To All Lamborghini Dealers and Licensed Service Point  
From Customer Service Department  
Subject Service campaign - Clamp for Misfire Pressure Sensor  
Group 140.1.31.00.05.ClampMisfirePressureSensor.GB  
Date 21.07.2005  
Pages 4

Clamps for misfire pressure sensors (p/n 07L906261)

Gallardo models until VIN ZHWG\_11\_\_5LA02586

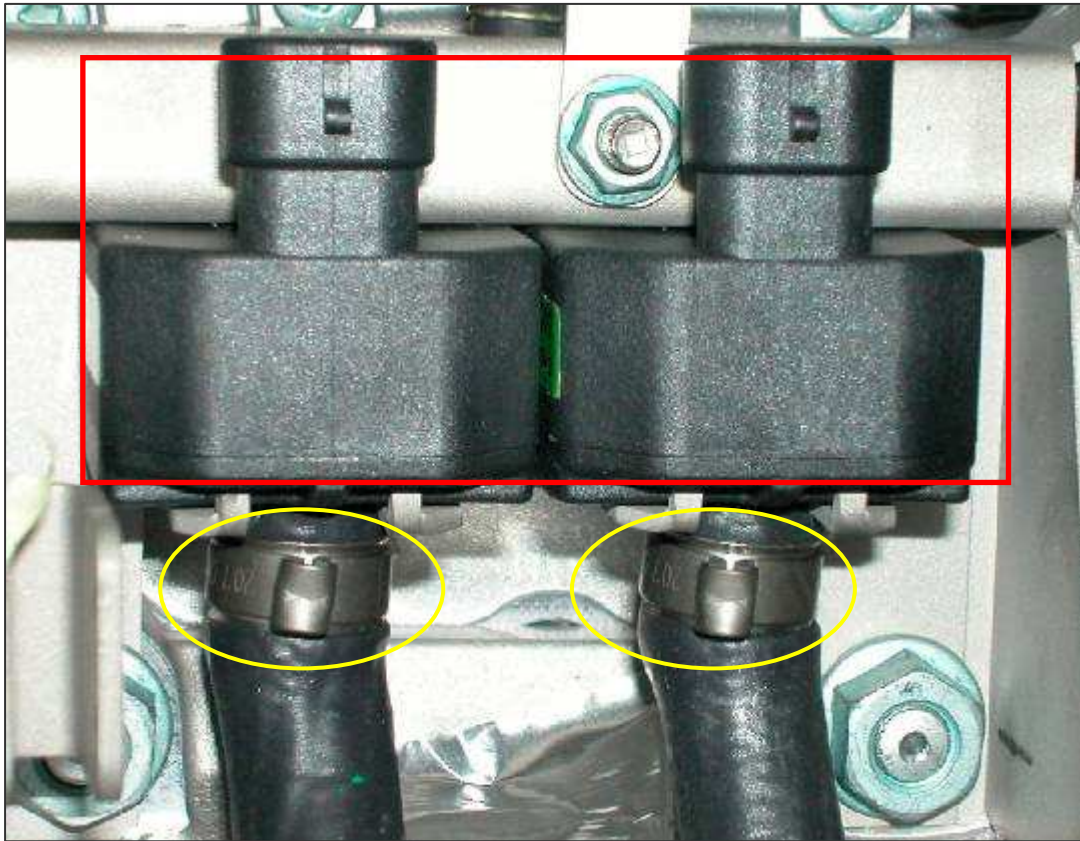
**1.2** Remove both misfire pressure sensors (see pictures below)

**1.3** Insert the clamps in the pipes where indicated in the picture below.
